HISTORIC PRESERVATION REVIEW BOARD STAFF REPORT AND RECOMMENDATION

Landmark/District:	Foggy Bottom Historic District	(x) Agenda
Address:	929 rear 25th Street NW¹	
Meeting Date:	June 30, 2022	(x) New construction
Case Number:	22-327	(x) Revised concept

Elevations from the 2020 concept application.

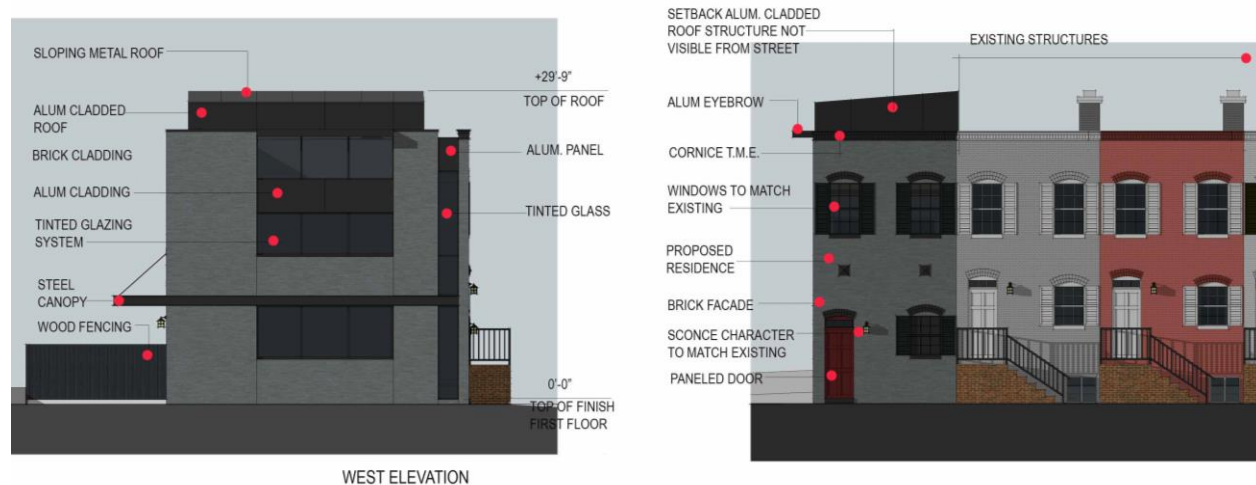
Two years ago, the Board reviewed and approved a concept for a three-level house, including its general height, boxy massing and its materials, and it delegated further review to staff, with the conditions that a pop-up slanted roof be eliminated; that the brick be either a compatible red or be painted; the fenestration be adjusted as suggested in the staff report; shutters be eliminated; the color of the metal panels be reconsidered; and that any code issues be addressed.
